WBN-TS-03-12

WATTS BAR NUCLEAR PLANT (WBN) – LICENSE AMENDMENT (WBN-TS-03-12)
MONITORING OF CONTROL OR SHUTDOWN ROD POSITION BY AN ALTERNATE
MEANS

**PROPOSED LICENSE AMENDMENT REQUEST WBN-TS-03-12
DESCRIPTION AND EVALUATION OF THE PROPOSED CHANGE**

Figure 2 – Proposed Monitoring of Stationary Gripper Coil

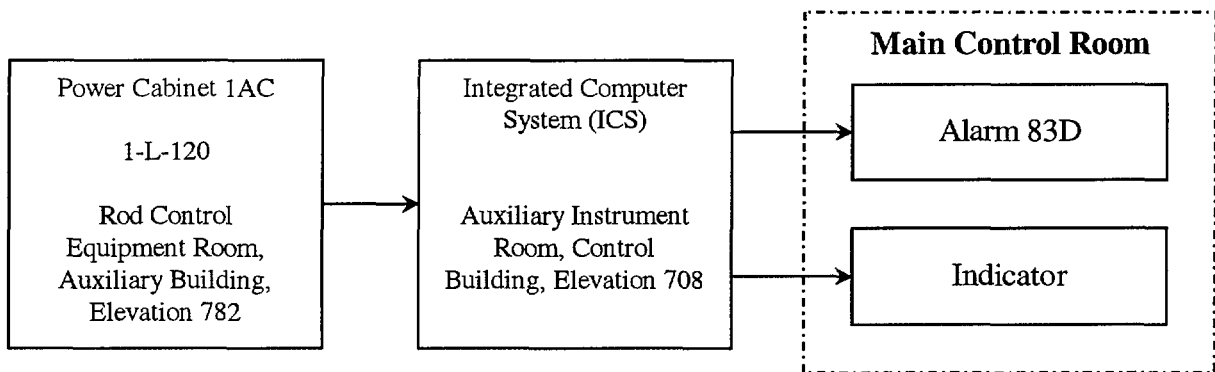
TVA plans to utilize the plant computer to monitor the stationary gripper coil voltage. Monitoring the inoperable ARPI in this manner will allow for historical data retrieval and will also allow the use of the existing rod deviation alarm. The “Rod at Bottom” status light and the “Rods at Bottom” annunciator for the affected control rod may be disabled. A simplified schematic of the monitoring circuit is provided below in Figure 2:

Since the monitoring will be performed by Operations, TVA proposes to continue the monitoring to determine if the coil has changed state on a once-per-shift basis or once every 12 hours. This is consistent with the 12 hour frequency of Surveillance Requirement (SR) 3.1.5.1 for the verification that the positions of the rods are within the alignment limits. Should the parameters of the coil of the monitored rod indicate unintended movement, a determination of the position of the rod will be made using the movable incore detectors. The position of the monitored rod will be established using the movable incore system at least once every 31 days in accordance with proposed action A.2.1.
